Access Compliance Report

Public Rights-of-Way

(Curb Ramps)

Intersection ID: 12629	Main Street: E_6TH_ST	Cross Street: N_DAVIDSON_ST	Location: NE
ADA ID: 8DAA2298703E	Ramp Type: Perp	Initial Pass/Fail: Fail	Overall Compliance: No
Severity Score: 22.5			
Codes/Mitigation Info/Possible Solution		Field Measurements/Component Compliance

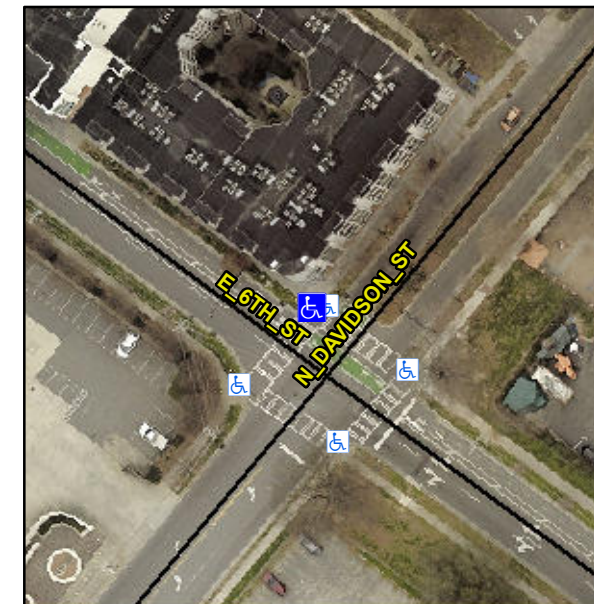
Not Found, R304.5.1, R304.2.2, R304.5.3

Compliance	Description	Data	Compliance	Description	Data
N/A	Ramp Length (in)	68.5	No	Ramp Slope (%)	8.4
No	Ramp Width (in)	47.0	No	Ramp XSlope (%)	5.0
N/A	Flare Type LT	N/A	N/A	Flare Type RT	N/A
N/A	Flare Slope LT (%)	N/A	N/A	Flare Slope RT (%)	N/A
N/A	Flare Traversable LT?	N/A	N/A	Flare Traversable RT?	N/A
N/A	Landing Length (in)	N/A	N/A	DWS Provided?	N/A
N/A	Landing Width (in)	N/A	N/A	DWS Contrast?	N/A
N/A	Landing Slope (%)	N/A	N/A	DWS Length (in)	N/A
N/A	Landing X Slope (%)	N/A	N/A	DWS Full Width?	N/A
N/A	Landing Curb? (Y/N)	N/A	N/A	DWS Offset (in)	N/A
N/A	Shared Landing?	N/A			
N/A	Gutter Ponding?	Yes	N/A	Gutter Slope (%)	N/A
N/A	Gutter Lip Ht (in)	N/A	N/A	Gutter X Slope (%)	N/A
N/A	Painted X Walk1?	Yes	N/A	Painted X Walk2?	N/A
	X Walk 1 Direction	To SW		X Walk 2 Direction	N/A
N/A	X Walk 1 Width (in)	108.5	N/A	X Walk 2 Width (in)	N/A
	X Walk 1 Slope (%)	6.5		X Walk 2 Slope (%)	N/A
	X Walk 1 X Slope (%)	2.0		X Walk 2 X Slope (%)	N/A

Remove & Replace Entire Ramp.
